Subject: HARD SHIFTING/SHIFT LEVER VIBRATION	Bulletin No: 05-001/15
	Last Issued: 11/11/2015

BULLETIN NOTE

- This bulletin supersedes the previous bulletins 05-008/14 issued on 07/14/14 and 11/26/14 and 05-001/15 issued on 01/05/15. The APPLICABLE MODEL(S)/VINS, DESCRIPTION, REPAIR PROCEDURE, PART(S) INFORMATION, and WARRANTY INFORMATION have been revised.
- Changes are noted below in Red beside the change bar.

Location of Transmission Related Parts

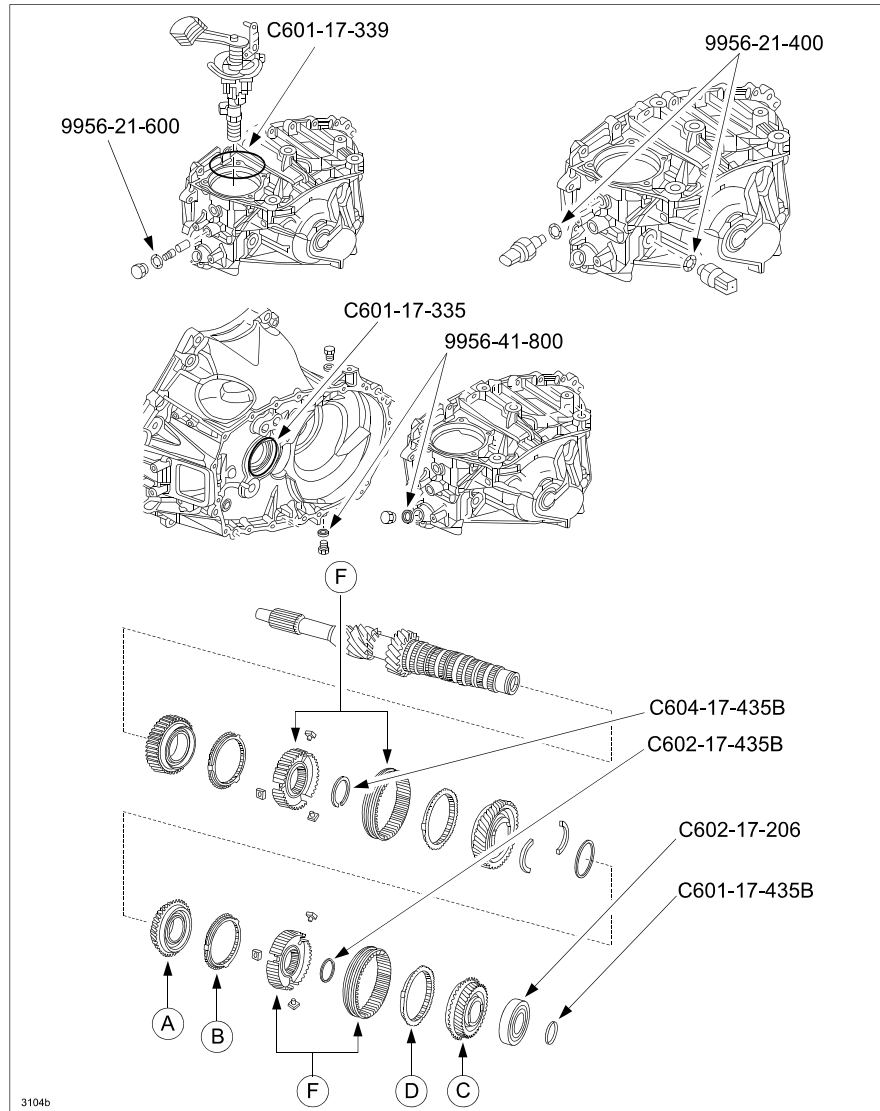
Modification	Mass-Production Change		Subject Concern
	Subject Part	Changes	
A	3-4 Clutch Hub	Surface treatment	Jumping out of gear
B	3-4 Clutch Hub 5-6 Clutch Hub	Shape	Hard shifting into 3rd, 4th, 5th and/or 6th gear
C	3rd and 4th Gears	Tolerance	Shift lever vibration
D	3rd and 4th Gears 3rd and 4th Synchronizer Rings	Shape	Hard shifting into 3rd and/or 4th gear (additional improvement)

- A: 3rd Gear
- B: 3rd Synchronizer Ring
- C: 3/4 Clutch Hub Assembly
- D: 4th Synchronizer Ring
- E: 4th Gear
- F: 5/6 Clutch Hub Assembly
